#### TOWN OF PALM BEACH

PLANNING, ZONING, & BUILDING DEPARTMENT PZ&B Staff Combination Memorandum: Landmarks Preservation Commission and Town Council

SUBJECT: COA-24-0002 (ZON-24-0009) 195 VIA DEL MAR (COMBO)

MEETING: JUNE 21, 2024, LPC JULY 10, 2024, TC

## **Addition**

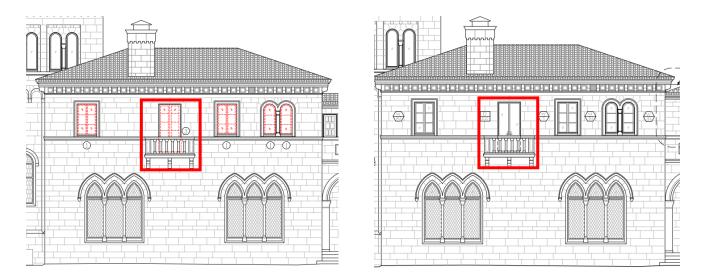
The proposed second-story addition is located on the northeast side of the residence. The approximately 510-square-foot space will house a new walk-in closet. The addition is proposed with a hipped roof finished with clay barrel tiles that match the roofing in the remainder of the residence. The fenestration includes wood casement windows with divided-light patterns and a bronze-framed pair of French doors. A new coquina façade is proposed with detailing that matches the residence. In addition, blind niches and modillions are proposed on the north elevation of the addition which creates visual interest in a façade void of openings. As indicated in the site data table, the addition's height exceeds the maximum allowance of 25 feet, however, the maximum overall height of 35 feet is not exceeded. Therefore, a variance to increase the maximum height to 29'-3" will be required. This variance request will be presented to the Town Council separately under ZON-24-0031.

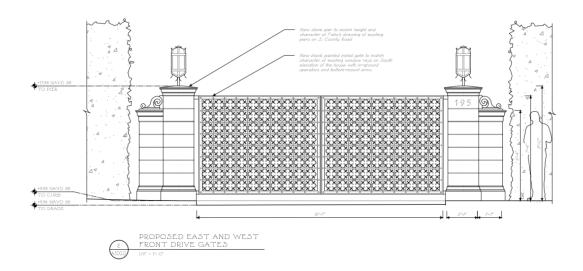
However, staff does have concerns regarding several French doors. These openings currently have divided-light patterns and are proposed to be replaced with full-view French doors. Analysis of the historical documentation does not provide precedence for this type of design in operable doors. Staff recommends that the existing divided-light patterns be replicated in the replacement products.

For example, the Juliet balcony French doors currently feature divided light patterns. The proposed replacement is full view:

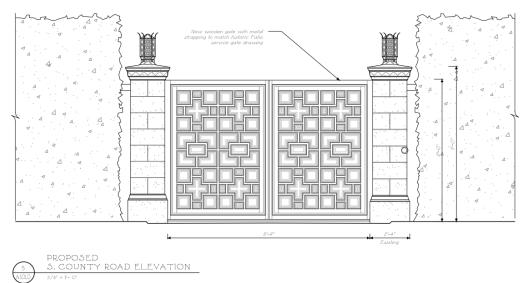
Along the Via Del Mar frontage, the existing stone piers that flank the gates will be raised to match the new pairs of swinging wrought iron gates. The detailing of the gates is inspired by Fatio-designed window ironwork.

The rolling gate along the South County Road frontage will be replaced with a new pair of wooden gates that are inspired by the original Fatio design for the gates at this location. However, the existing location of the gate and piers does not provide the minimum of 18 feet to the street pavement as required per Section 134-1668. Therefore, a variance is required to reduce the required ve

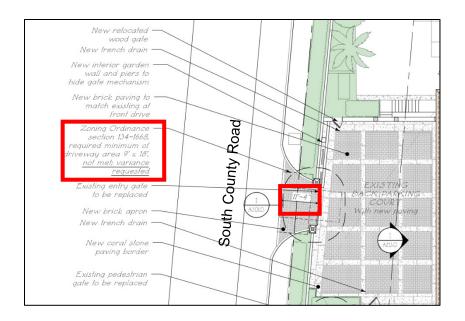
The variance request is summarized in the table and diagram below:

<b>Code Section</b>	Required	Proposed	Variance
Variance:	18'	11'-4"	6'-8"
Sec. 134-1668	Driveway Depth	Existing Driveway Depth	0 -8

## Hardscape and Landscape Modifications

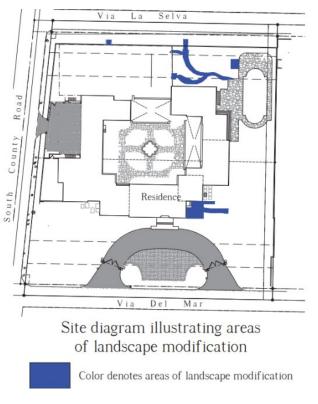
Minimal hardscape and landscape changes are proposed. A mechanical equipment unit will be relocated outside of the building setbacks. An existing Calophyllum Brasiliense (Brazilian Beauty Leaf) shrub will be removed on the southeast side of the property. In addition, a small portion of Brazilian Beauty Leaf hedging will also be removed along Via La Selva to accommodate a new pedestrian gate. Lastly, existing shrubs and ground cover will be relocated to create a new path leading to the new pedestrian gate.
